Service Campaign Bulletin

Campaign No. 2016110001, December 2016

SUBJECT: **Models 205, 217, 222, 253; Model Years 2015-2017**
Check Relays in Rear Fuse and Relay Module

Figure 1

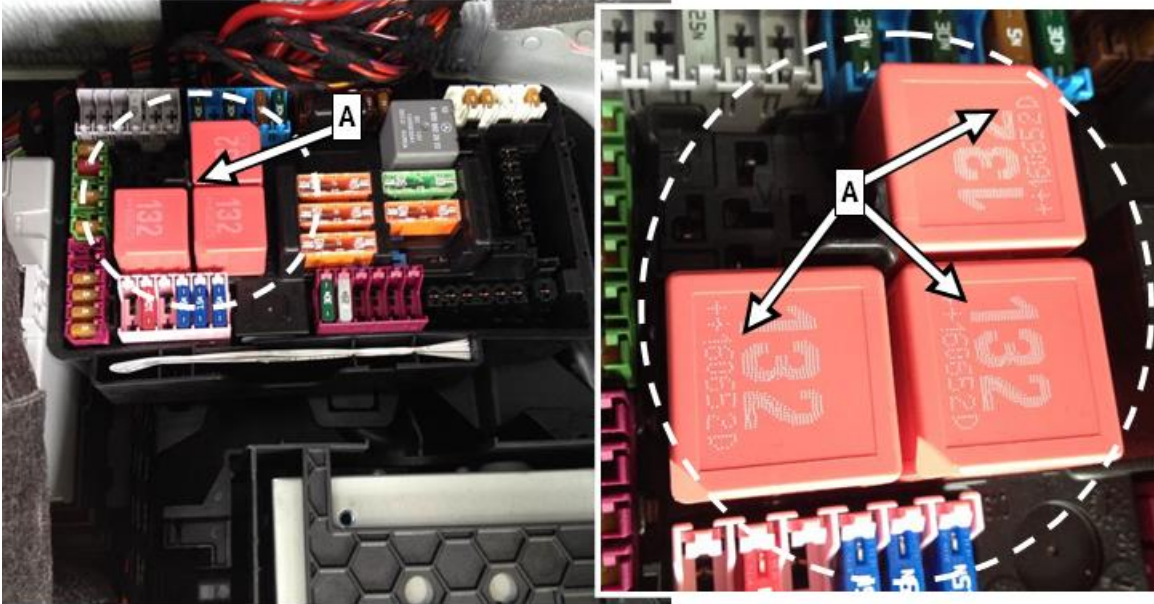
1. Open trunk lid, fold up trunk covering and hook in.
2.  Lift paneling of spare wheel well or cover above rear fuse and relay module.
3.  Check manufacture date of three relays (A, Figure 1) in rear fuse and relay module.

- If relay(s) do **NOT** have date code of: **1529** (15=year, 29=week) **(OK)**: Reassemble in reverse order, Procedure is complete.
- If relay(s) **have** date code of: **1529** (15=year, 29=week) **(NOT OK)**: Proceed to **Subject C**.

Figure 4 (Not OK) 1529 (15=year, 29=week)

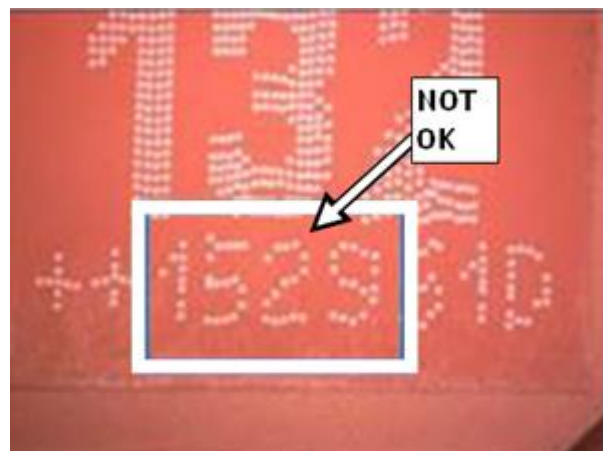
- If relay(s) do **NOT** have date code of: **1529** (arrow, Figure 4) **(OK)**: Reassemble in reverse order, Procedure is complete.
- If relay(s) **have** date code of: **1529** (arrow, Figure 4) **(NOT OK)**: Proceed to **Subject C**.

1.  Remove “old” relay(s) and replace with “new” relay.
